Spartanburg Community College
Cherokee Campus Whelchel Road Entranceway
Project No. H59-N153-MJ

Addendum Two
September 28, 2023

CV2.1 2101

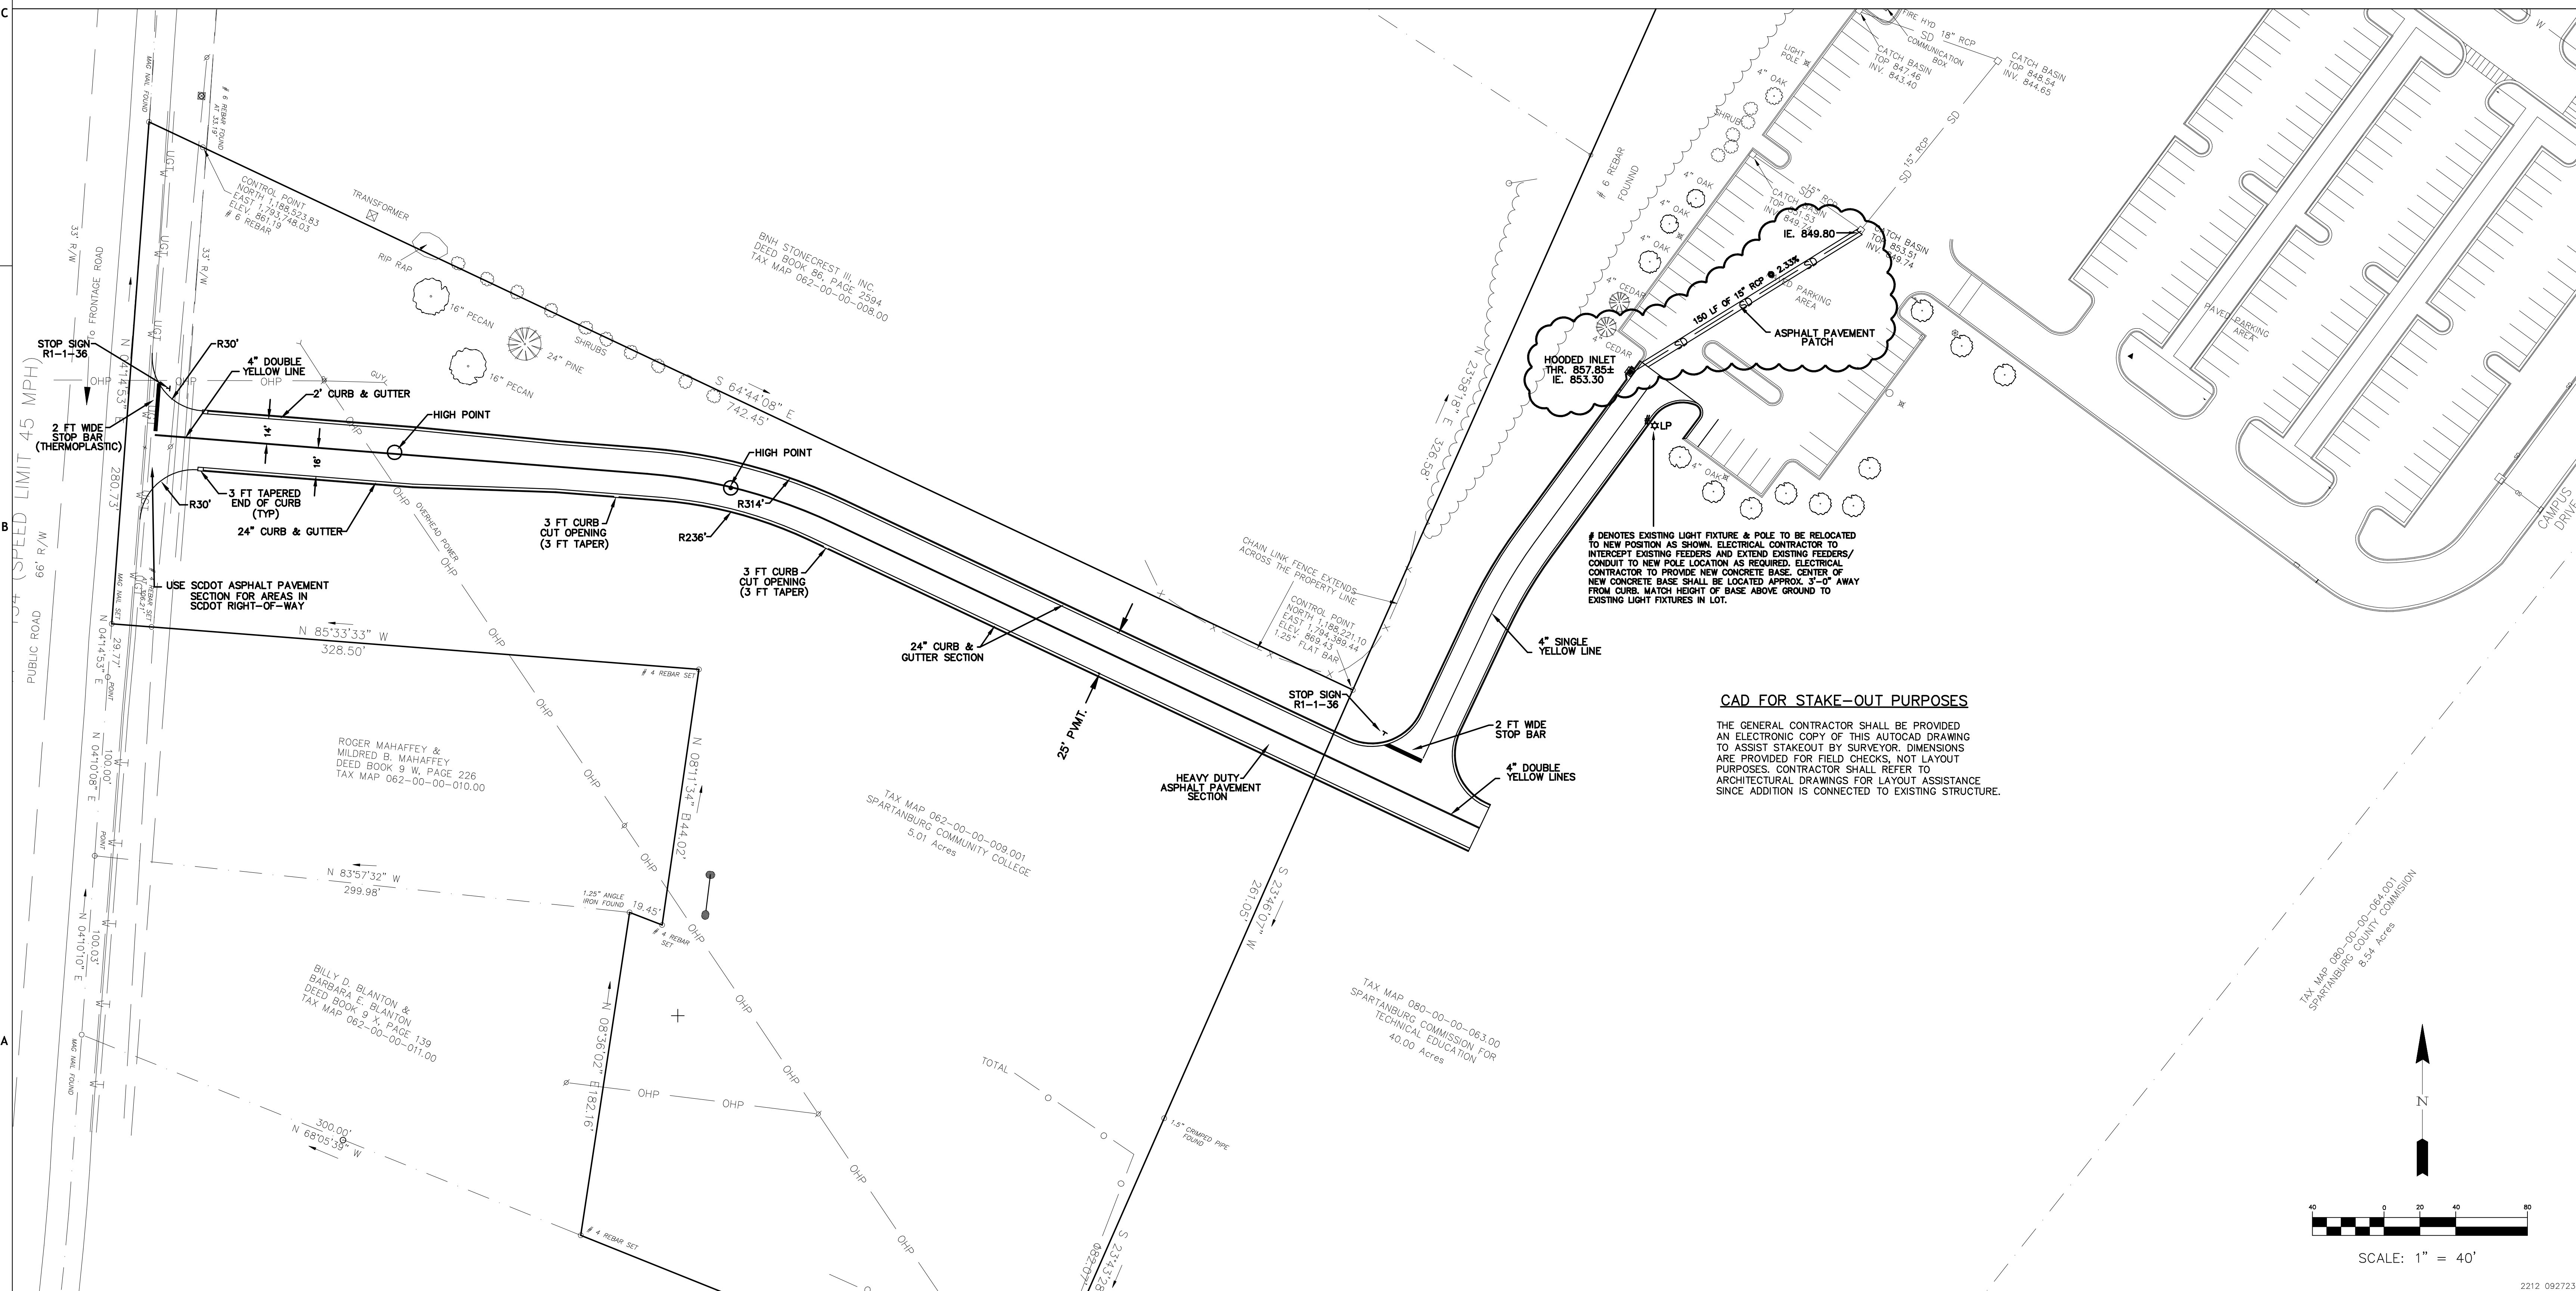
Item No. 1: The new catch basin near the drive connection to the existing CAMIT parking lot is a hooded agree inlet (Detail 4.1L) with a throat elevation of 857.85 and invert elevation of 853.30. The storm drain pipe is 150 LF of 15" RCP laid at 2.33%, and connects to the existing grate inlet basin in the CAMIT parking lot. These items are part of the project scope. See revised CV2.1 (attached).
